**ECN/PCN No.: M1215**

For Manufacturer			
<b>Product Description:</b> Mini Drum Core Inductor	<b>Abracon Part Number / Part Series:</b> AIUR-02H Series	<input type="checkbox"/> Documentation only <input checked="" type="checkbox"/> ECN <input type="checkbox"/> EOL	<input checked="" type="checkbox"/> Series <input type="checkbox"/> Part Number(s)
<b>Affected Revision:</b> L	<b>New Revision:</b> M	<b>Application:</b>	<input type="checkbox"/> Safety <input checked="" type="checkbox"/> Non-Safety

**2.1 Test Conditions and equipments**

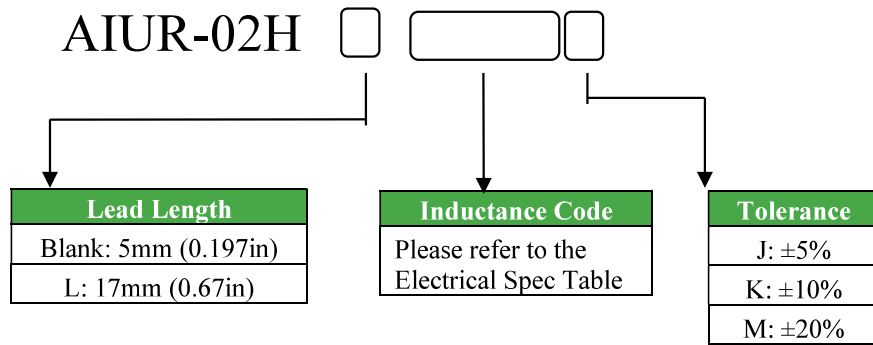
DCR: QuadTech Milliohmeter

Isat: 10% inductance drops from initial value

I<sub>bc</sub>: The DC current at which the temperature rise is 40°C max

**5.1 Test Conditions**

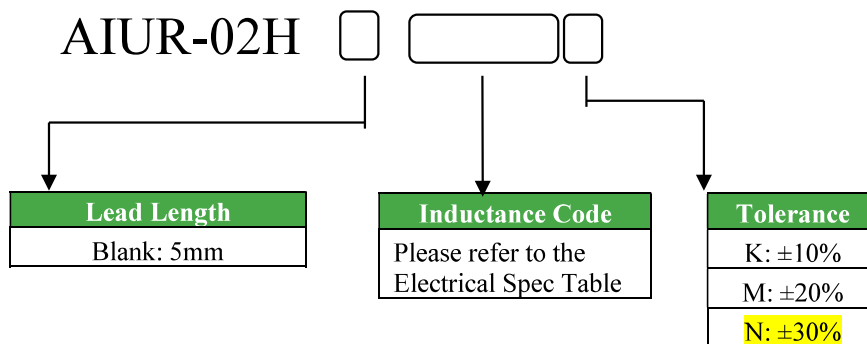
Test frequency: 1KHz, 0.25V

Isat: 30% inductance drops from initial value.

I<sub>DC</sub>: The DC current at which the temperature rise is 40°C max.

**7.0 Mechanical Dimensions**

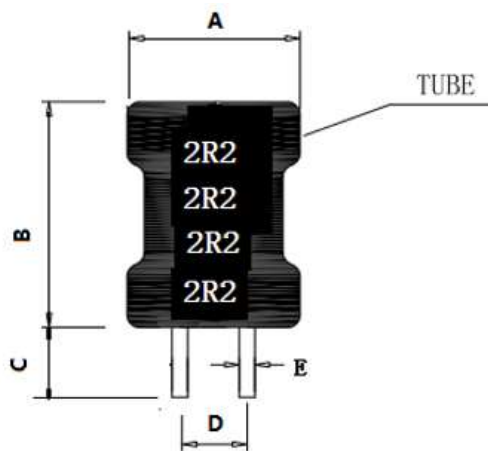
A	B	C	D	E
9.0 (max)	12.0 (max)	5.0±1	5Ref	0.6
